# MAPLIN NEWS

## MATINEE ORGAN UPDATE

Following the 2-page section in our last issue we have now found three more possible problems. The page numbers refer to the construction book XH55K.

Figure 13. Piano re-trigger modification (tantalum end).

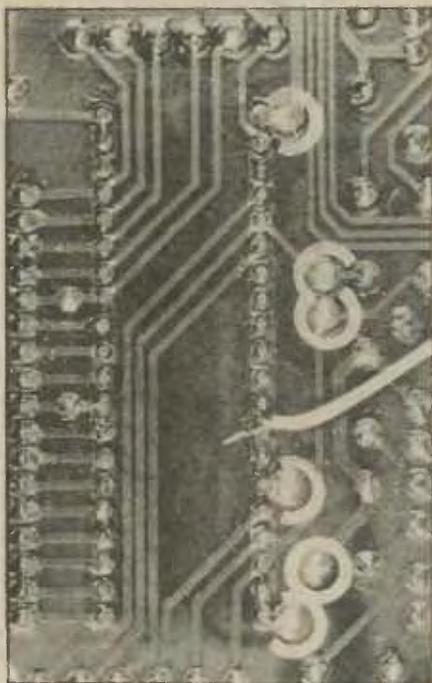
24. If you wish the piano to re-trigger when an additional note is played, connect a 1 $\mu$ F 35V tantalum capacitor with its negative lead to the negative end of C179 and its positive lead via a length of wire to the unused pin 13 of IC44. See Figure 13 & 14.

Figure 15. Elimination of click on Wah switch (underside).

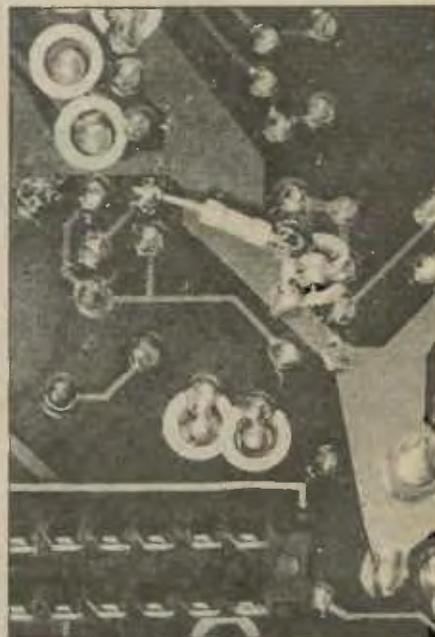
26. Some constructors have noticed an audible click or thump when Wah is turned on for the first time. To eliminate this, add two resistors. One, a Min Res 470k should be connected under the pcb between the collector and emitter of TR51. See Figure 15. The second, a Min Res 100k, is connected on the top side of the pcb at S34, between the centre and back pins of the left side of section 'a'. See Figure 16.
